ISSUED ADDENDUM

Date	6/18/2020
Addendum Number	1
Project Number and Name	218042 Demolish and Replace Barracks and Latrine Facilities 02108-02113
Invitation to Bid Date	5/13/2020
Number of Attachments	7
Bid Opening Date and Time	6/25/2020 (2:00 PM – St. Augustine, FL)

ADDENDUM NO. TWO

**DEMOLISH & REPLACE BARRACKS & LATRINE FACILITIES 02108-02113
CAMP BLANDING JOINT TRAINING CENTER
STARKE , FL
For FLORIDA DEPT. OF MILITARY AFFAIRS**

C-2.0
 BID SUBMITTAL

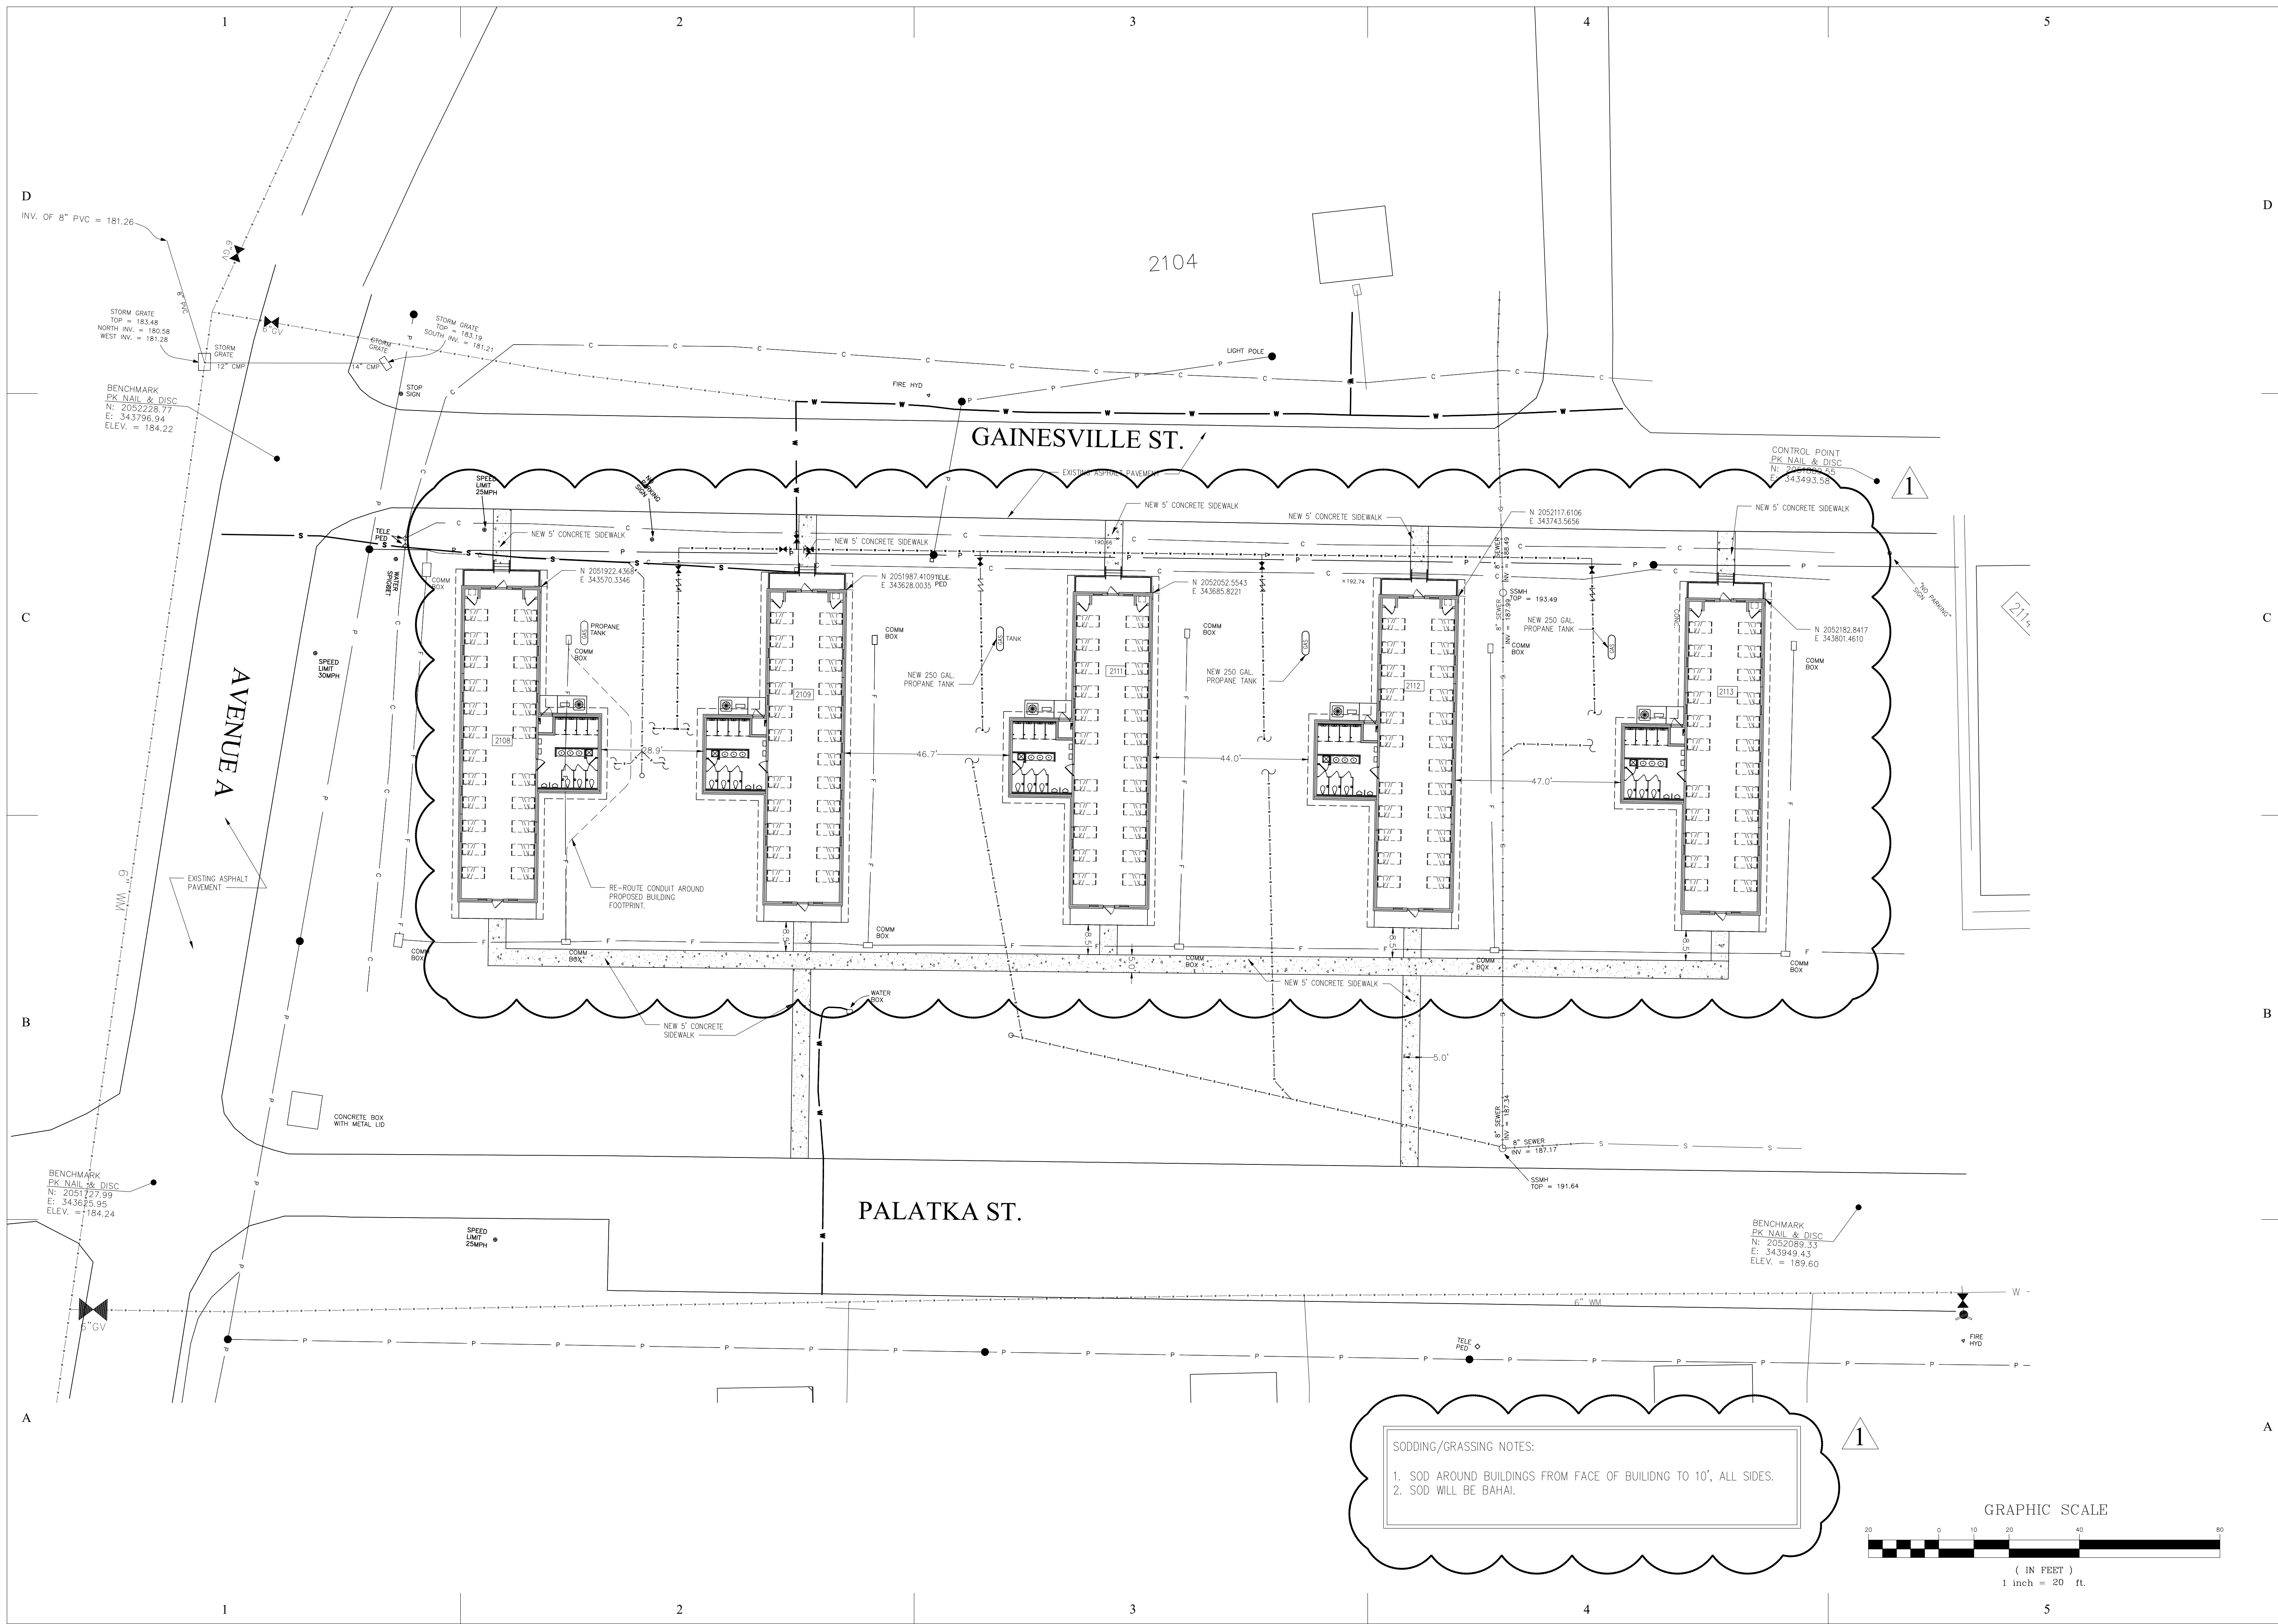
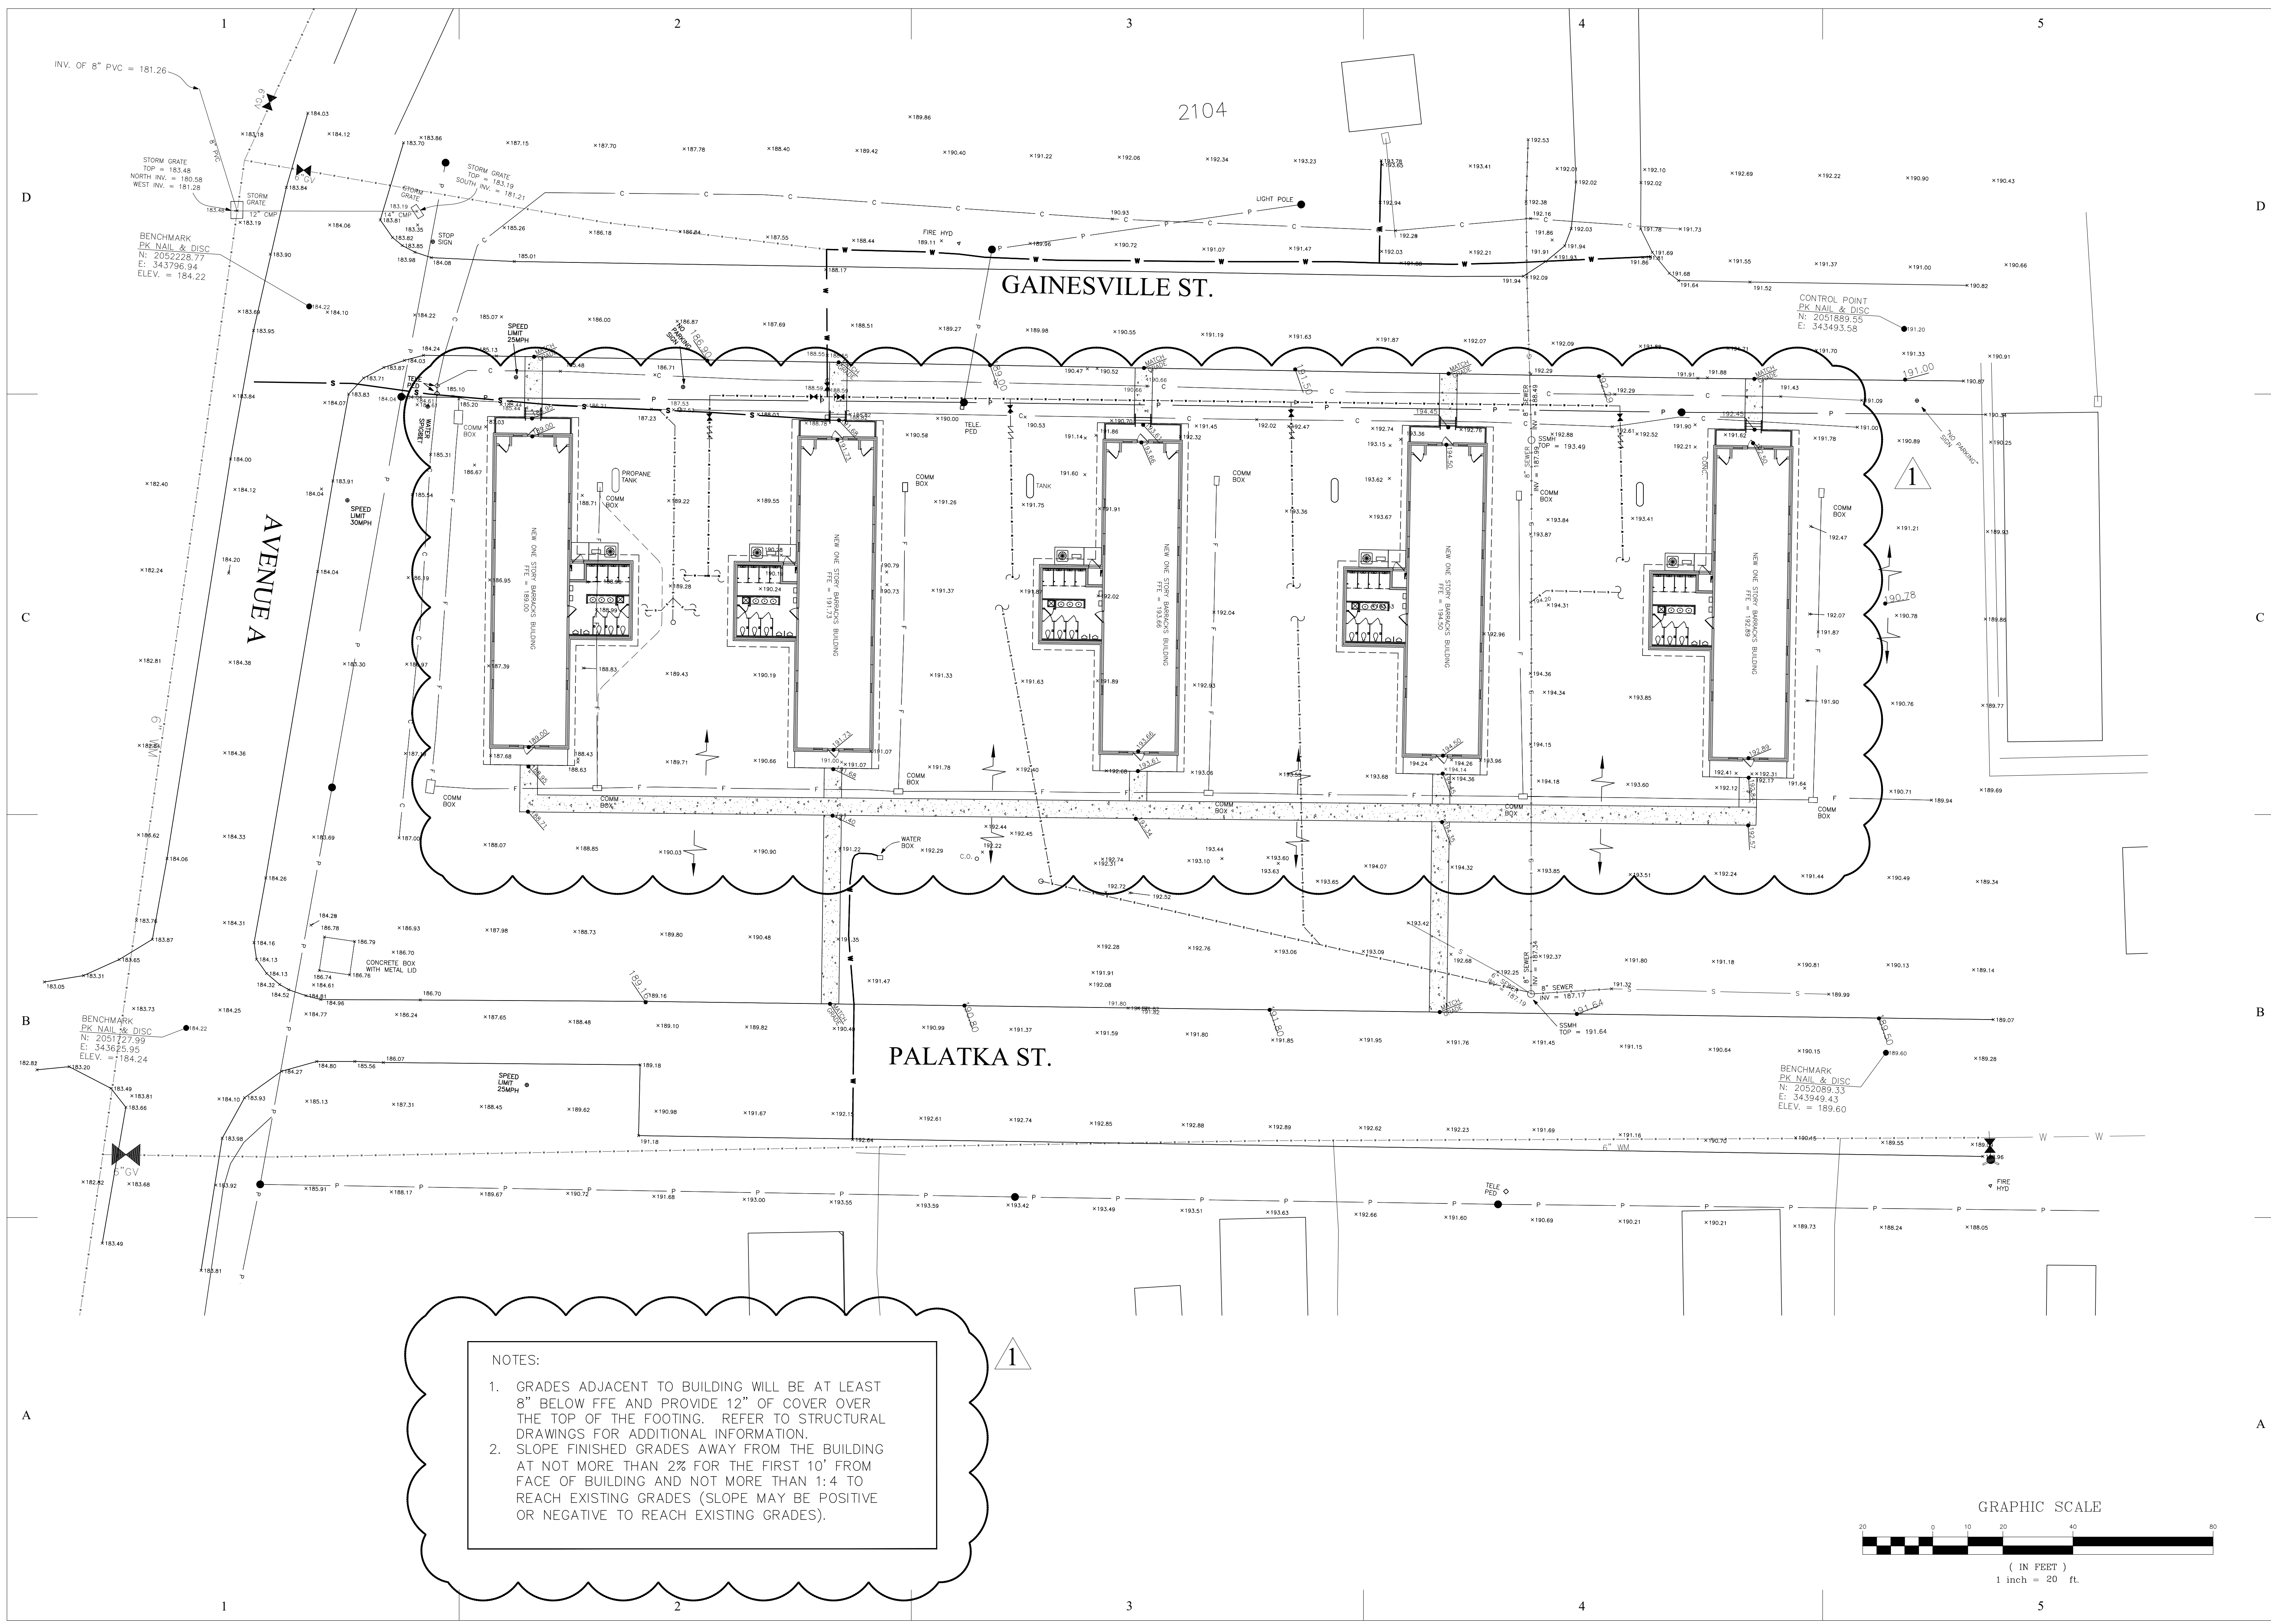
Sheets C-2.0, C-3.0, C-3.1 and C-4.0 have been revised in order to provide additional information and clarification in response to questions asked in RFI #002. Please see RFI #002 reply for additional information.

1. It appears slab orientation on civil drawings is reversed from architectural drawings. Please clarify.

Response: Orientation of buildings shown on architectural drawings is correct. Please see revised civil drawings C-2.0, C-3.0 and C-4.0 issued by Addendum #002 for updated information.

C-3.0
 BID SUBMITTAL

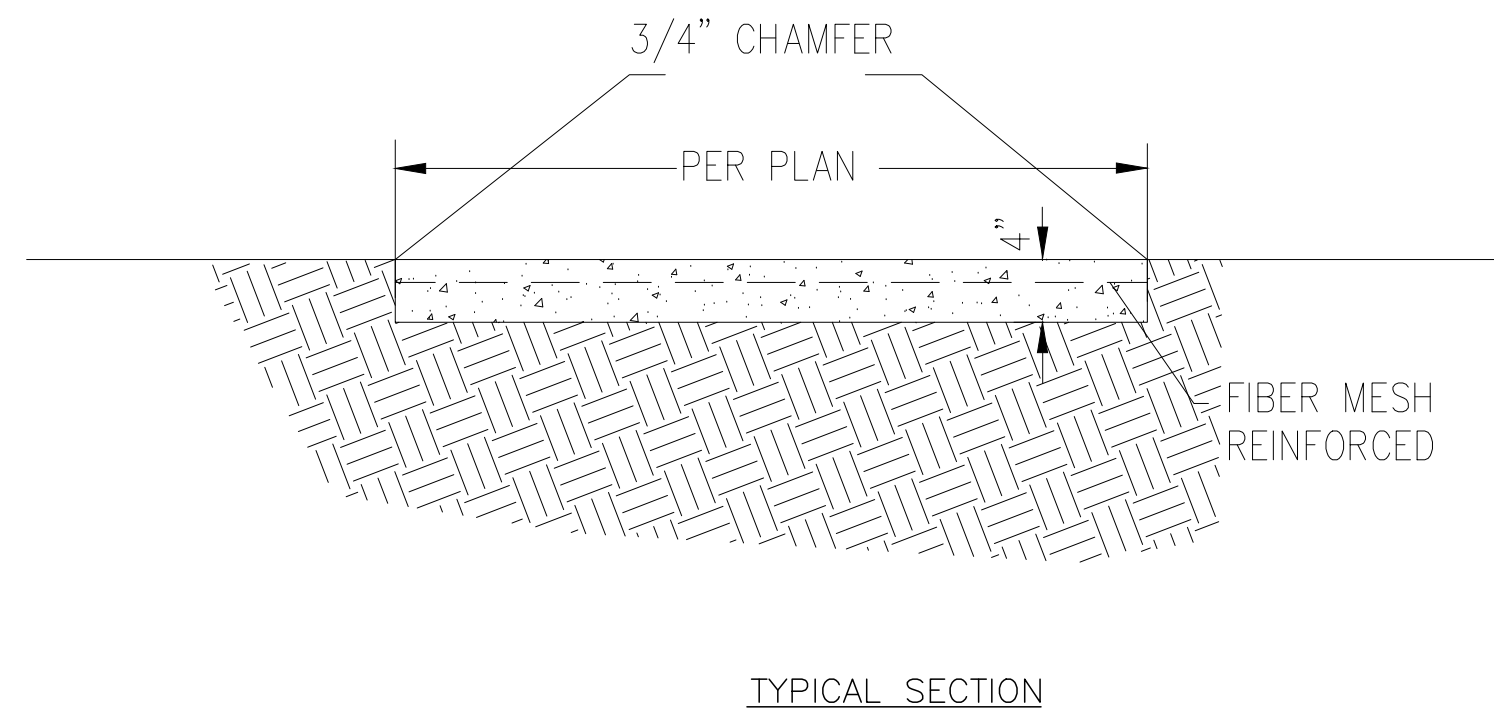
2. Civil drawings page C-3.0 appears to be a grading and drainage plan. Site elevations all appear to be existing. Note #2 on that page, makes reference "to reach existing grades". This infers existing grades to remain with the exception of FFE and implementation of items #1 & #2 of that page. Upon review, it appears the entire site will require regrading due to several conflicts and conditions not conducive to requirements of item #2. Can grading points be provided so that an accurate cost of grading, balancing, and import/export of dirt can be determined?

Response: See revised General Notes on Sheet C-3.0 issued by Addendum #002 for additional information regarding grading requirements at and around all buildings as well as within the project site boundaries.
